INTERNAL MEMORANDUM

To:	Adam Foote
From:	Matt Davies (Ecologist)
Ext:	5278
Memo number:	3 Final
Date of previous memo (for Pre-App Enquiry):	04/10/2023
Date of previous memo (for P/23/0065)	08/06/2023
Date:	15/07/2024

SUBJECT: P/23/0065 | Outline application for erection of a mixed leisure development comprising Indoor Snow Centre (up to 39,200 sq m), Water park (up to 7,500 sq m), Indoor Activity Centre (up to 9,000 sq m), Outdoor Activity Centre, Hotel Accommodation (up to 418 bedrooms), Woodland Lodge accommodation (up to 30 units), car parking (up to 830 spaces) and associated earthworks, access, drainage, servicing and utilities connections/infrastructure | Land To The South West Of The A470/A4102 Roundabout At Rhydycar West Merthyr Tydfil

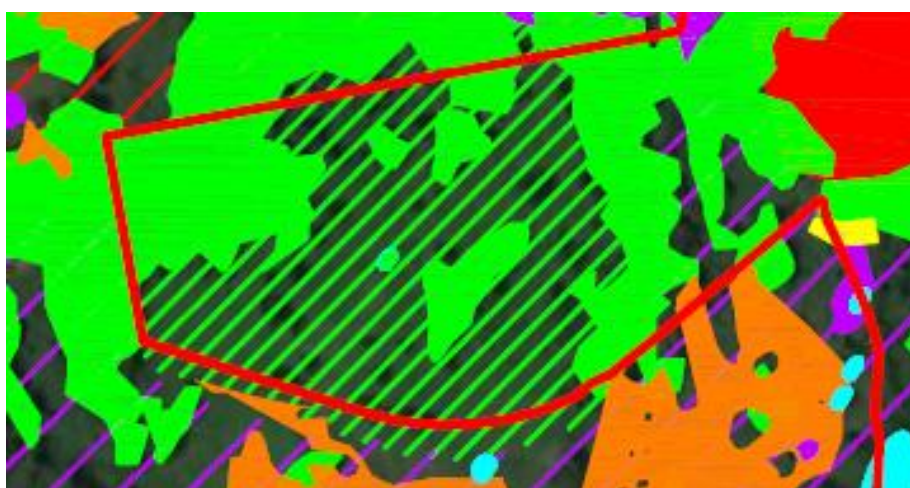
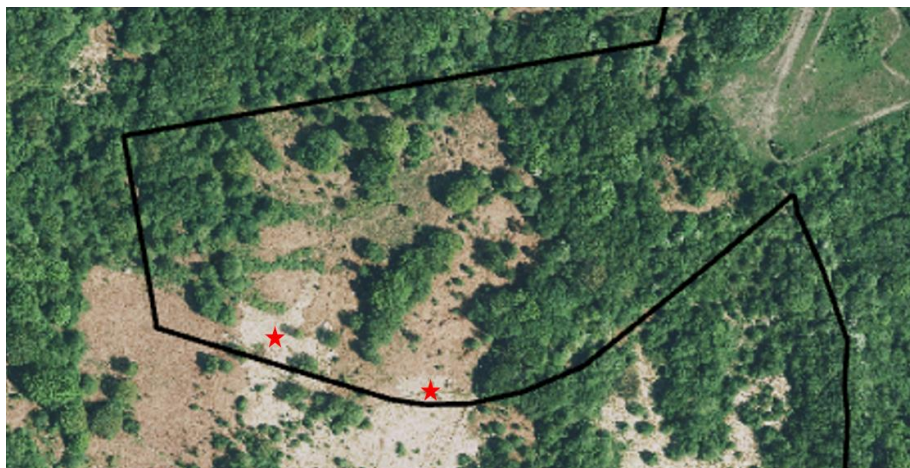
1. The habitats within the section of SSSI to be impacted by the proposed development (as mapped by Bioscan) include ‘Woodland and Scrub’, ‘Bracken Ffridd’ (these two habitats combined dominate), with smaller areas of ‘Purple moorgrass rush pastures’, ‘Lowland heathland’ and plus a habitat type not included within the key (shown on the plan as purple diagonal lines).

Furthermore, aerial imagery of the area in question from 2023 shows other clear areas of marshy grassland (Molinia) on the southern boundary (near the red stars) shown on the habitat map as within the Bracken Ffridd – see plans below.
